GMP #84

SUBJECT: Approval of Septic Tanks
Onsite - Product Approval - Septic Tanks

GMP #84
Onsite - Product Approval - Septic Tanks

TOP VIEW

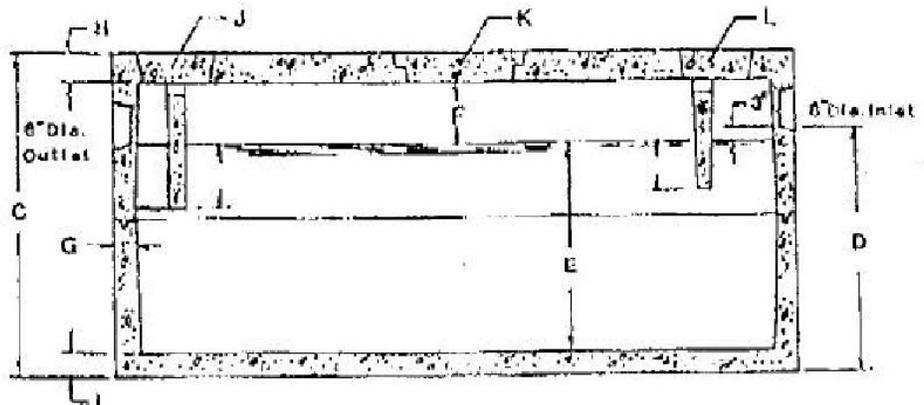
I have reviewed the plans for the 1,000, 1,250, and 1,500 gallon septic tanks with the use of fiber mesh in place of the 6 by 6 inch #12 welded wire mesh. The plans appear to comply with the minimum requirements of the Sewage Handling and Disposal Regulations.

You are proposing to use either Fibermesh(R) or CAPROLAN-RC Nylon Fibers as an alternative to the welded wire mesh. The use of both of these alternative fiber mesh has been previously approved by the Department (Refer to GMP#16 and the letter from the Director dated July 8, 1986). The use of fiber mesh does not replace or substitute for the use of reinforcing rods, when the reinforcing rods are required.
